Review of information provided regarding the removal of a Mature Oak at 9 Barnards Way

Application reference 20/00652/TRE

Johnathan Harpham

03/11/2021

Level Monitoring illustrating a POSITIVE movement rather than negative

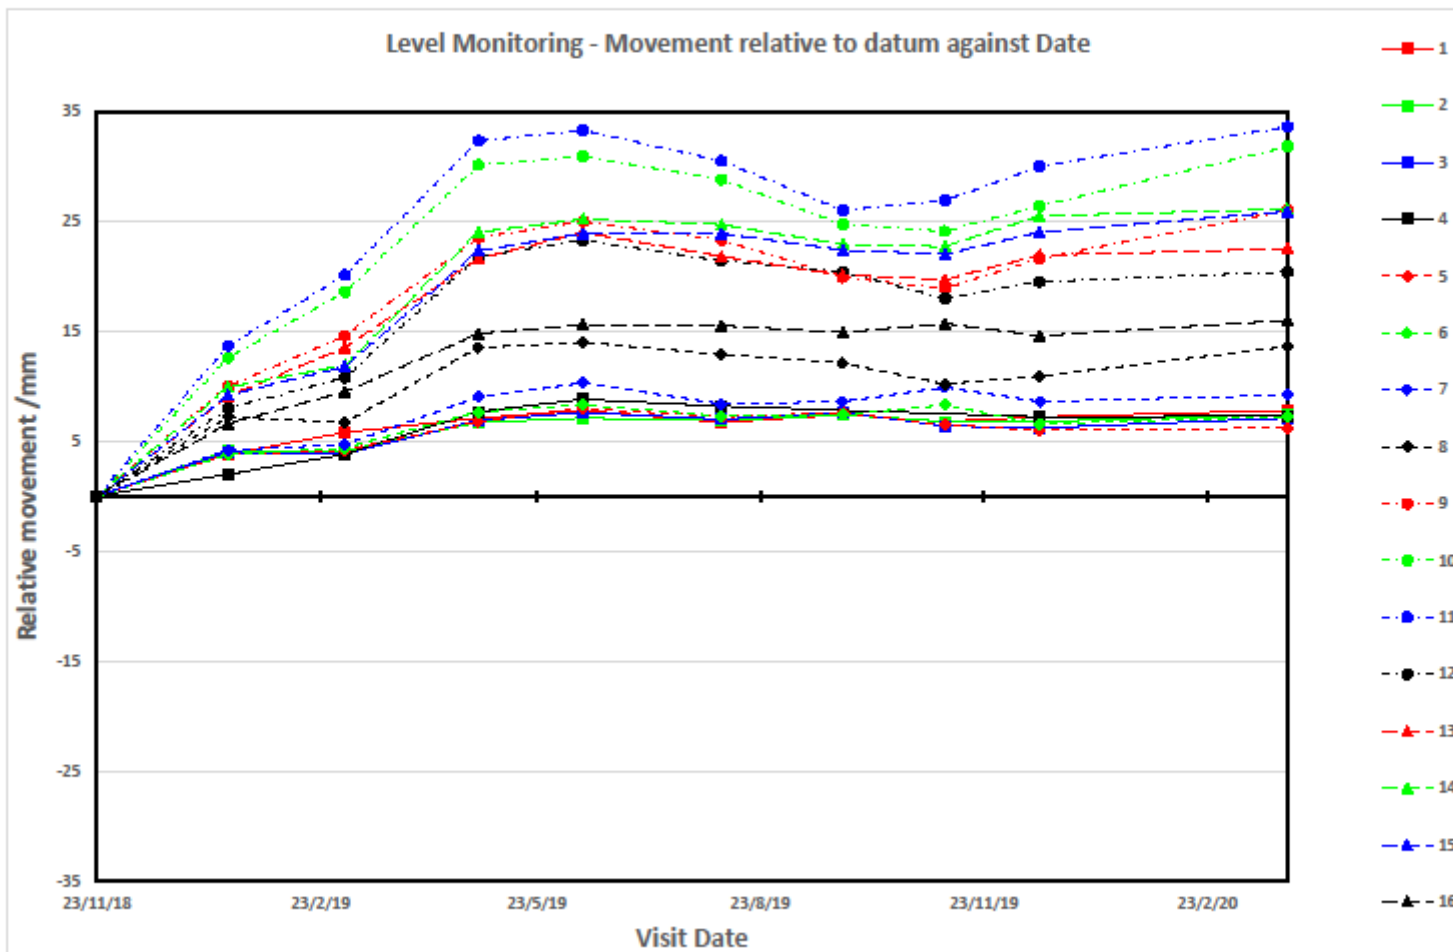
The level monitoring clearly indicates a **positive** figure across all 16 points, although these figures are greater to the points contained to the rear of the property. A positive figure usually indicates heave rather than subsidence. As clay soil rehydrates it expands, the volume of which is defined by the plasticity index. By plotting the dates with the highest increase in height against the rainfall obtained from the Cambridge NIAB weather station via the met office website, it would appear that these changes are in line with rehydration from rainfall in both the month prior and during the month of the level monitoring visit.

While there are differences in height increases from the front of the property to the rear, the rear being where there are the largest changes in height, these are greater on the conservatory than the actual house. This would be in line with the difference in loadings between foundations, the house foundation bearing more weight and being more substantial, rather than a difference in volume change potential, as indicated in the GSTL Liquid limit, Plastic Limit and Plasticity index report dated 05/03/2019 whereby TH1 test results indicates plasticity index of 23% at 0.85m depth and 21% at 1.35 while TH2 indicates at plasticity index of 40% at 1.3, 38% at 1.8, nothing recorded for 2.3 with 27% at 2.8
